**Re: Lougheed Transit Corridor Area Plan; 2nd reading
Council meeting Dec. 9, 2025**

The HUB Cycling Maple Ridge/Pitt Meadows Committee appreciates the opportunity to provide feedback on this important area plan.

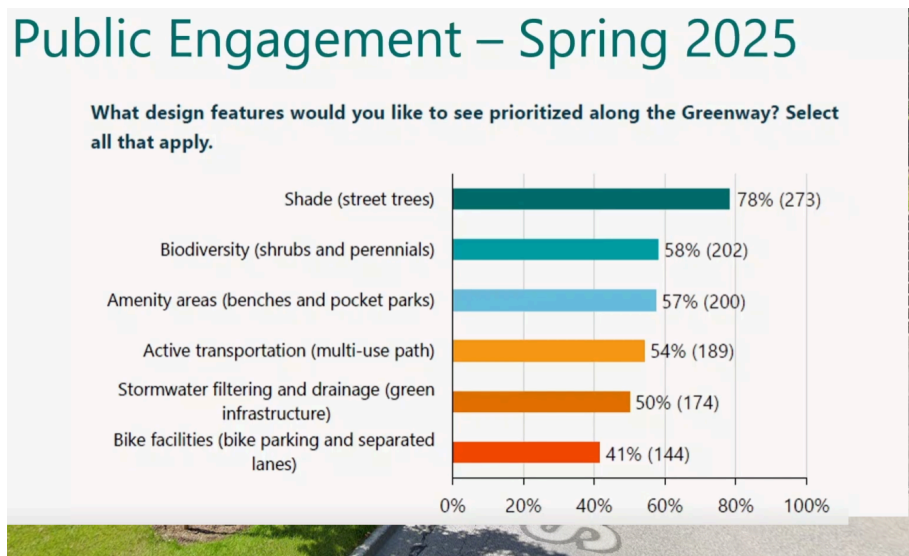
Lougheed Hwy is owned by the Province, and the Province and TransLink are the decision makers there. The City merely has an advocacy role. TransLink has informed our HUB Cycling Committee that cycling infrastructure will **not** be part of the road widening project to add Bus Rapid Transit (BRT) lanes in the coming years. Cycling facilities will largely be added "over time", mostly through re-development. A reliable source informed us very recently that multi-use paths **may** be planned on both sides, but again, there is much uncertainty. No details are given in the LTCAP with regard to what it is that the city is actually advocating for.

Will the need for land acquisition mean that it may always be a pipedream? Like Dewdney Trunk Road?

Ask #2: We ask the City to clearly state in the LTCAP what it is advocating for in terms of design and timelines of AT along Lougheed Hwy.

Figure 2
Lougheed Transit Corridor Mobility Network

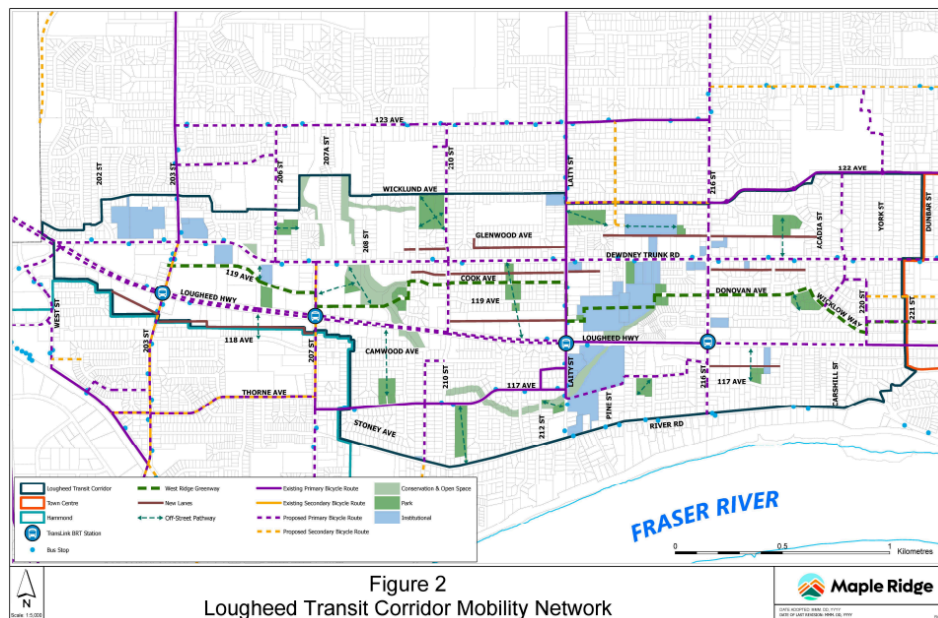
- Laity Street is shown as an existing Primary Cycling Route. This is incorrect. It is shown in the 2023 STP as an existing Secondary Cycling Route. It is comfortable for few. This is an important cycling route for multi-modal traffic as it connects directly to one of the future BRT stations.

- The proposed Primary Cycling Route along Lougheed Highway west of Laity is shown as a double dotted line. Does this mean that MOTT, TransLink and the City have determined that this segment of Lougheed Highway will have cycling facilities on both sides, and east of Laity Lougheed will only have cycling facilities on one side?

- The Primary Cycling Route connecting 210 Street south of Lougheed appears to be incomplete as a planned route. Again, we would like clarification as to whether or not this is planned to be a future road connection, replacing the present pedestrian pathway. This would make this cycling route less attractive for cycling.

Ask #5: We request the City to make the requested corrections and/or provide clarification.
